Re: Florida Power & Light Company
Proposed Turkey Point Units 6 and 7
Docket Nos. 52-040 and 52-041
Response to NRC Request for Additional Information Letter No. 037
(eRAI 5896) SRP Section - 02.05.02 Vibratory Ground Motion

NRC RAI Letter No. PTN-RAI-LTR-037

SRP Section: 02.05.02 - Vibratory Ground Motion

NRC RAI Number: 02.05.02-2 (eRAI 5896)

Figure 9b. Caribbean 25Hz weighted mean attenuation curve for a magnitude 7 earthquake.

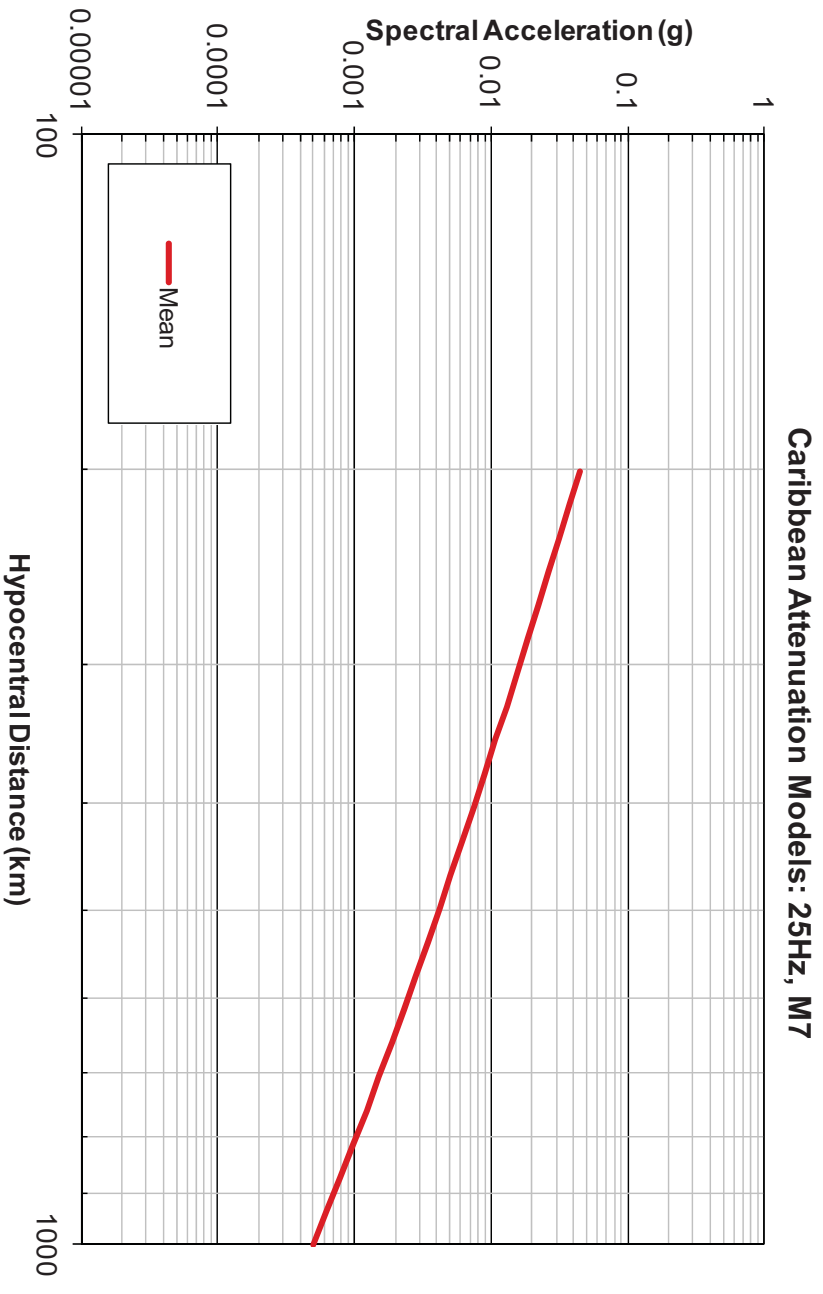
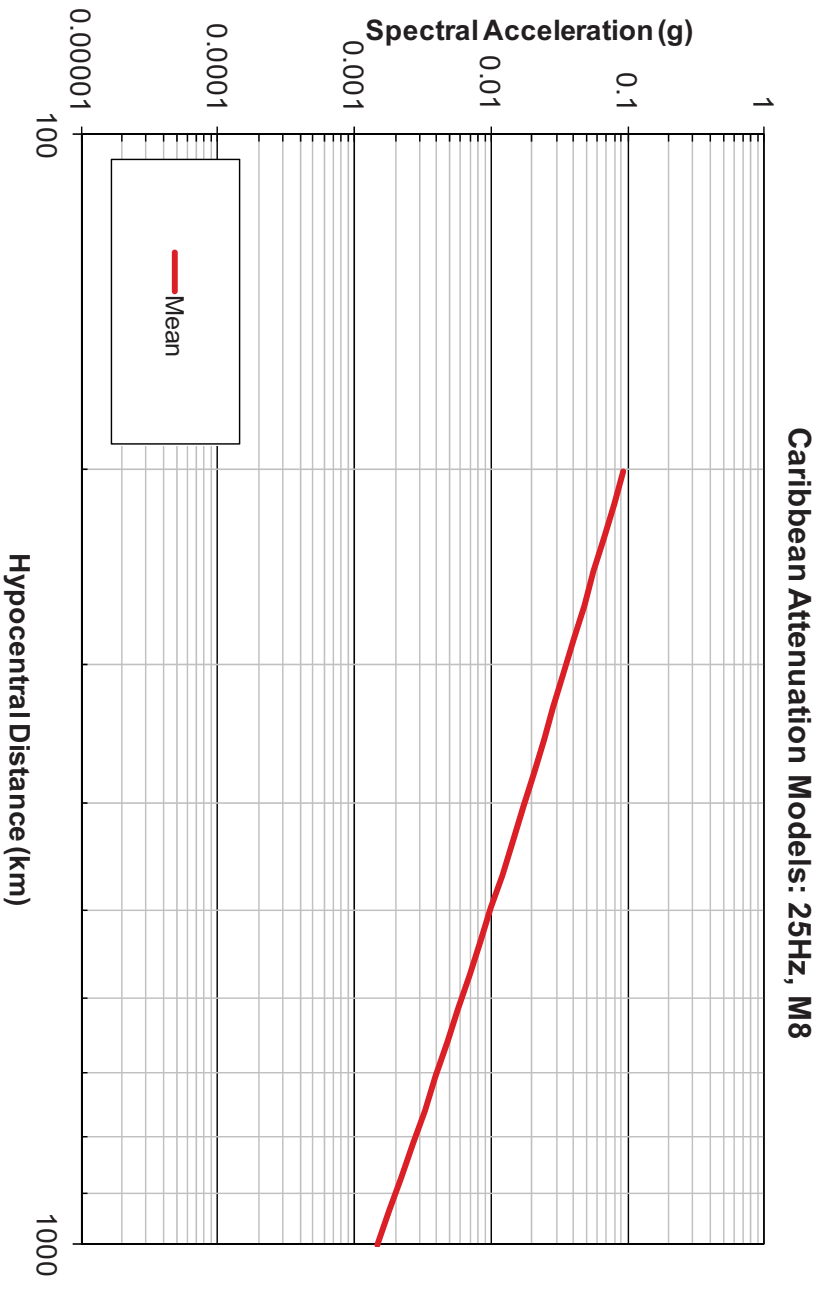
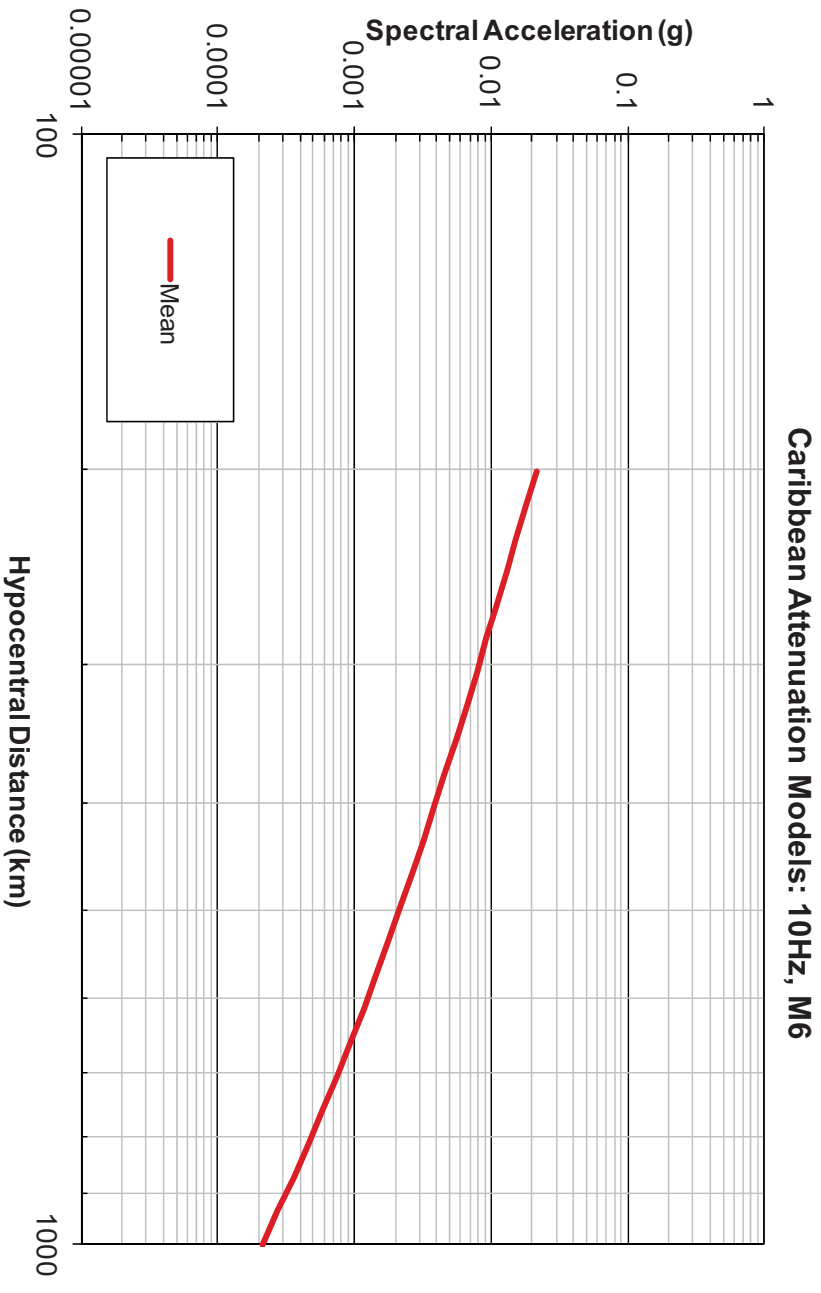
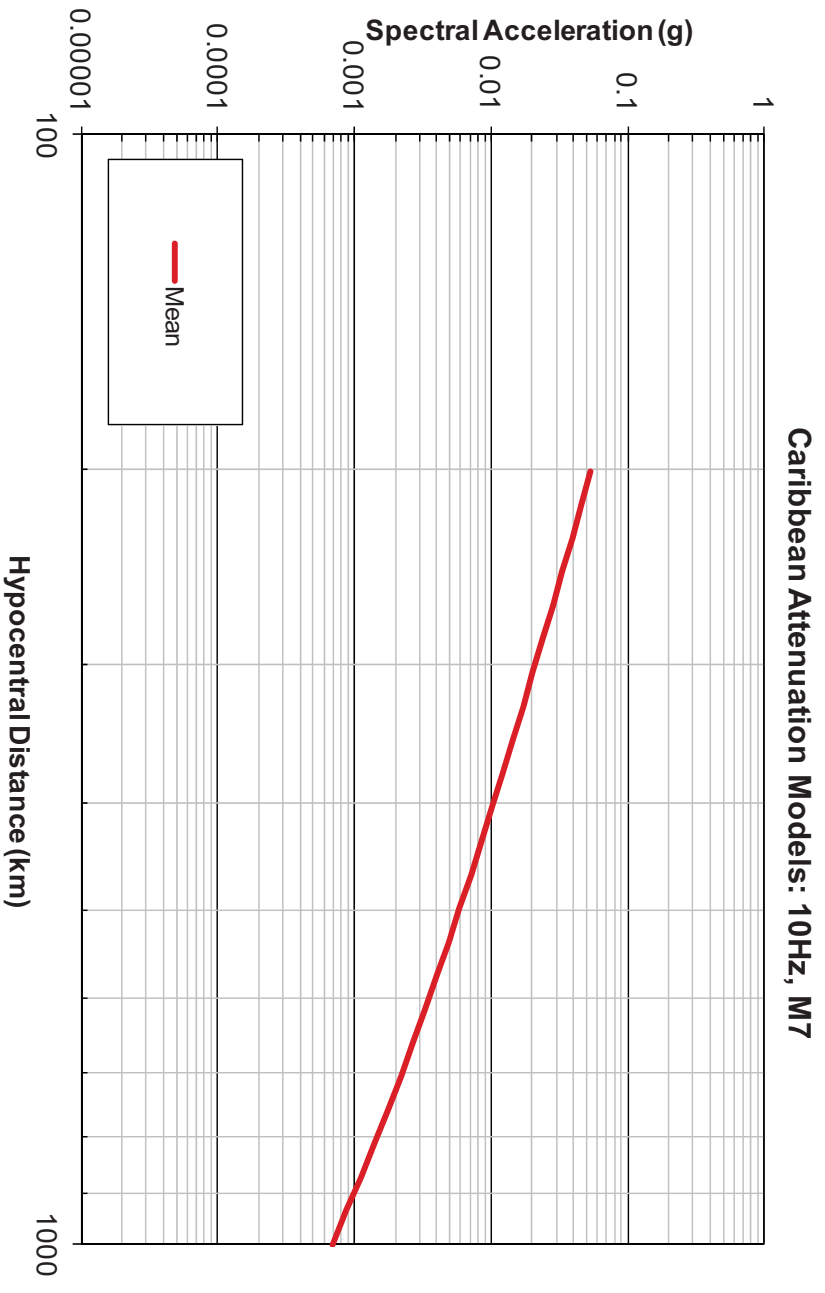
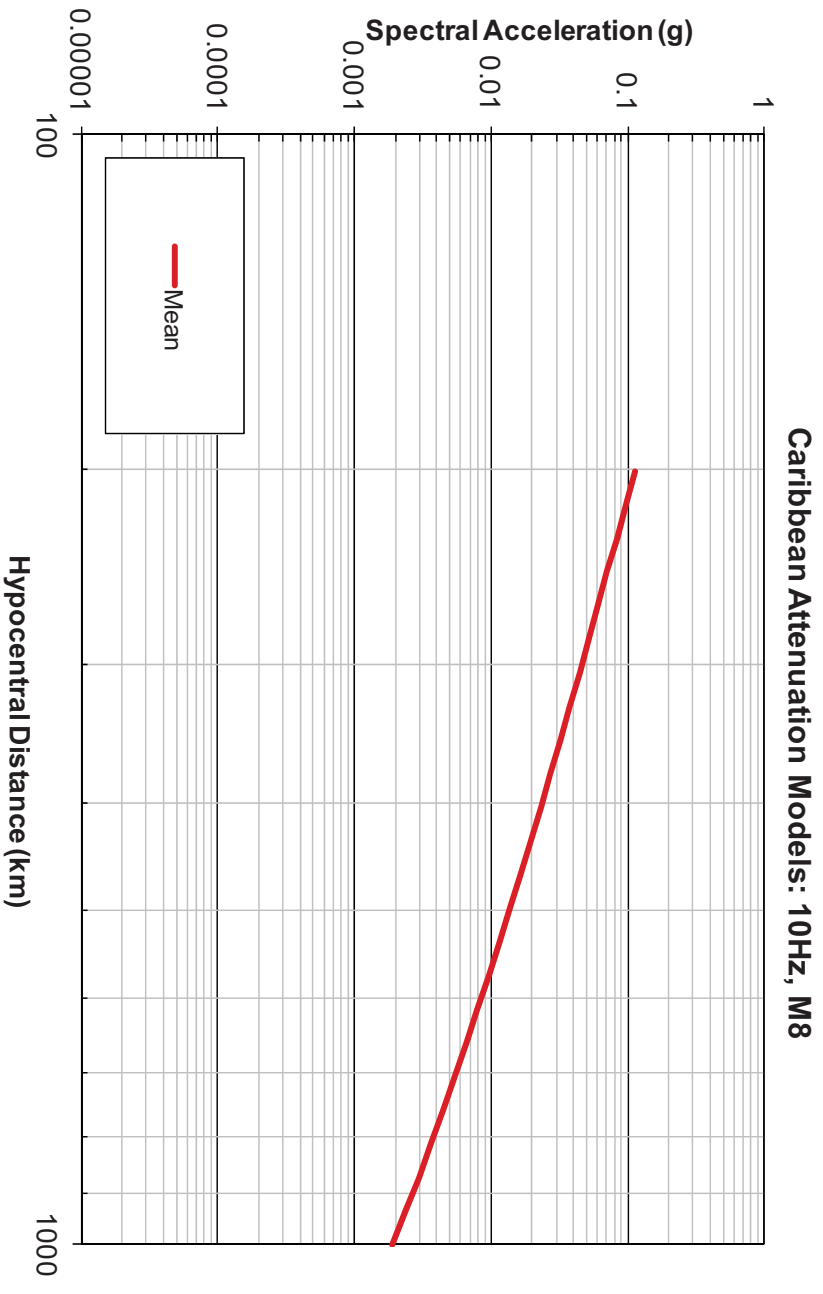
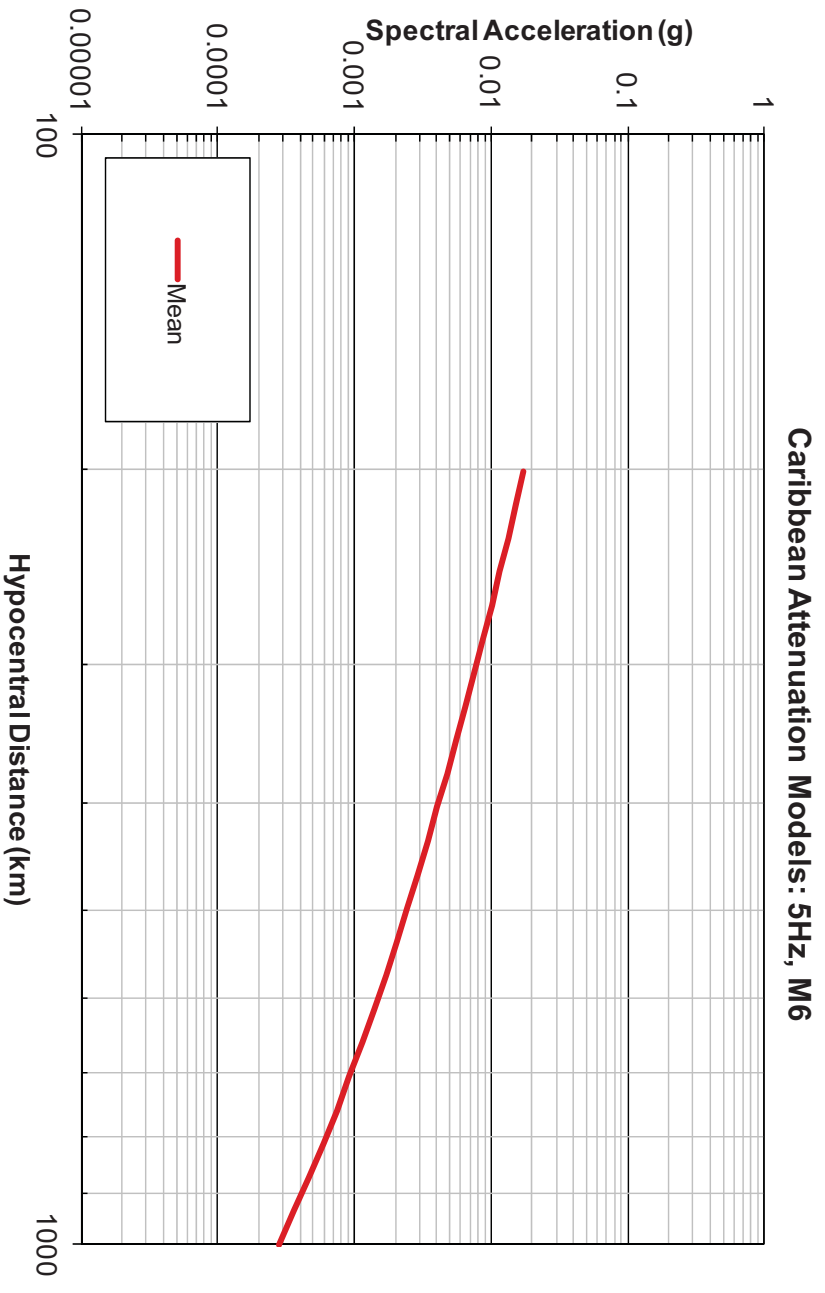
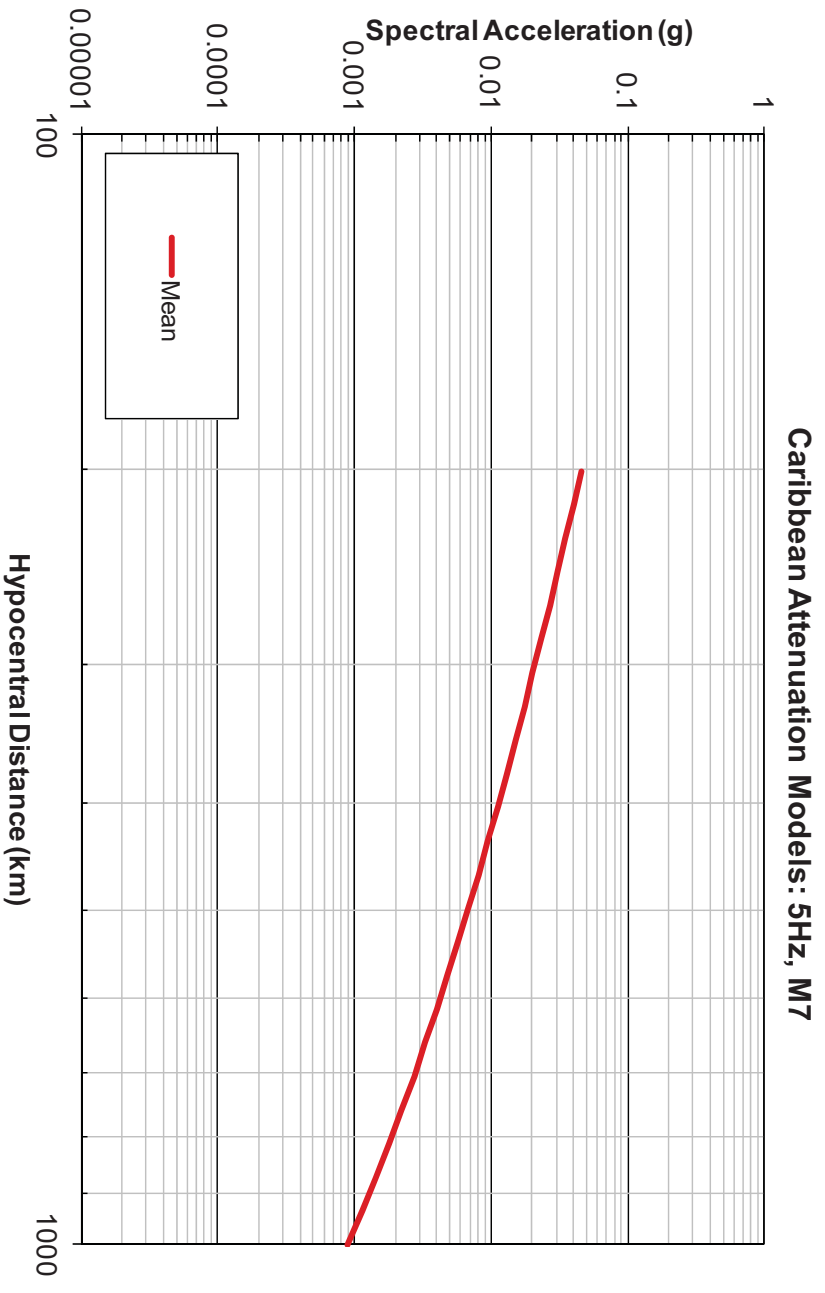
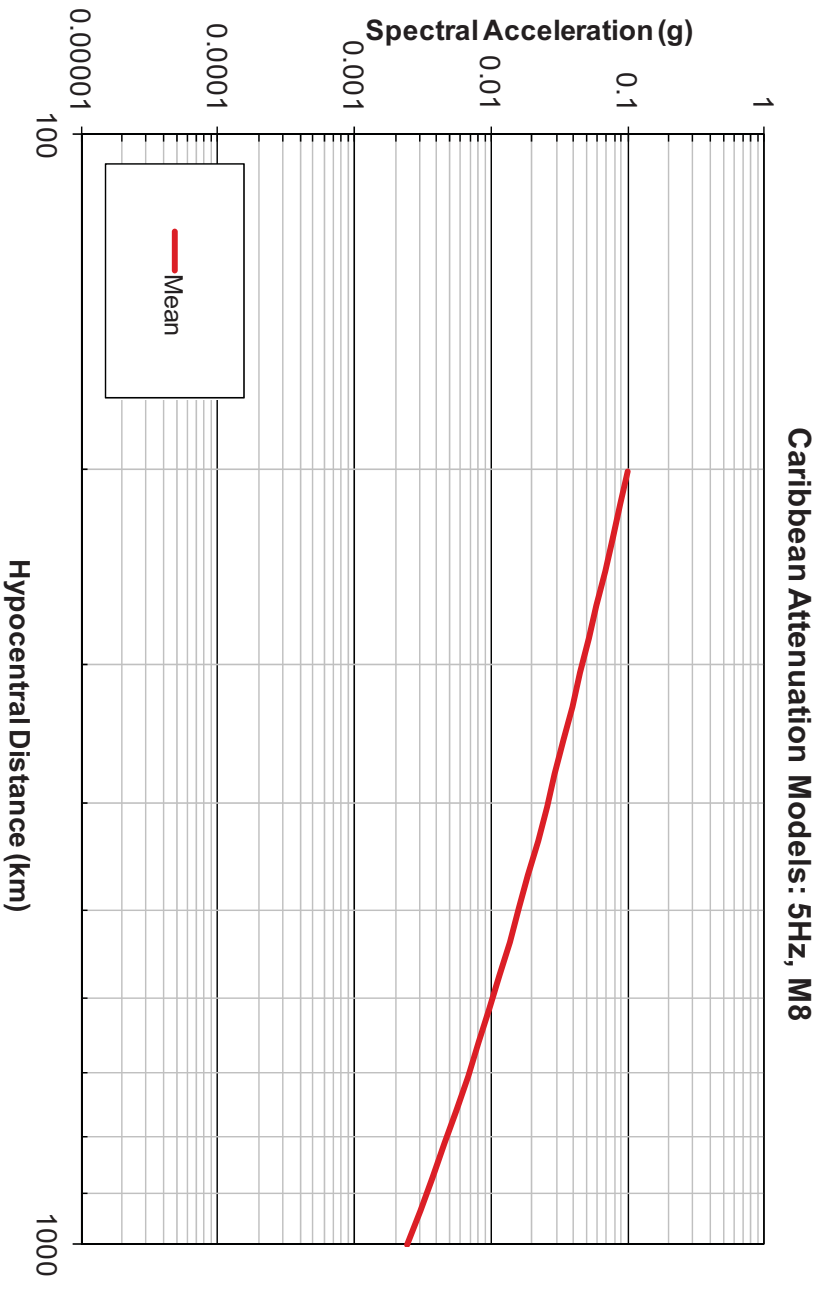
- d. In order for the staff to be able to compare the new Caribbean GMPEs with the 2004/2006 EPRI mid-continent GMPEs, please provide plots showing both ground motion models for earthquake magnitudes of 6.0, 7.0, and 8.0 in the distance range of 200 km to 1000 km at all seven frequencies defined in the EPRI 2004 and 2006 GMPEs.

Ground motion attenuation curve plots are provided for the EPRI (FSAR References 242 and 203) and Caribbean ground motion prediction equations (GMPEs). Note that EPRI (FSAR Reference 203) is only a recommendation for the associated aleatory uncertainty and therefore does not impact the comparison plots of the weighted mean ground motion

attenuation curve. The plotted mean attenuation curve is the weighted mean of the individual median attenuation curves as defined in EPRI (FSAR Reference 242). These attenuation plots are provided for three specific moment magnitude (M_w) values: 6, 7, and 8 for distances between 200 km and 1,000 km. Note that the EPRI (FSAR Reference 242) ground motion attenuation model is defined as a function of epicentral distance, whereas the Caribbean ground motion attenuation model is defined as a function of hypocentral distance. However, because the closest distance is 200 km, the difference between the epicentral and hypocentral distances would be less than 1% for a typical crustal depth of 10 km and even smaller for larger distances out to 1,000 km.

The weighted mean ground motion attenuation curves for the EPRI (FSAR Reference 242) model are given in Figures 1 through 7 for the three magnitudes and seven spectral frequencies requested in the RAI. The weighted mean Caribbean ground motion attenuation curve plots for the same suite of magnitudes, distances, and spectral frequencies are shown in Figures 8 through 14.
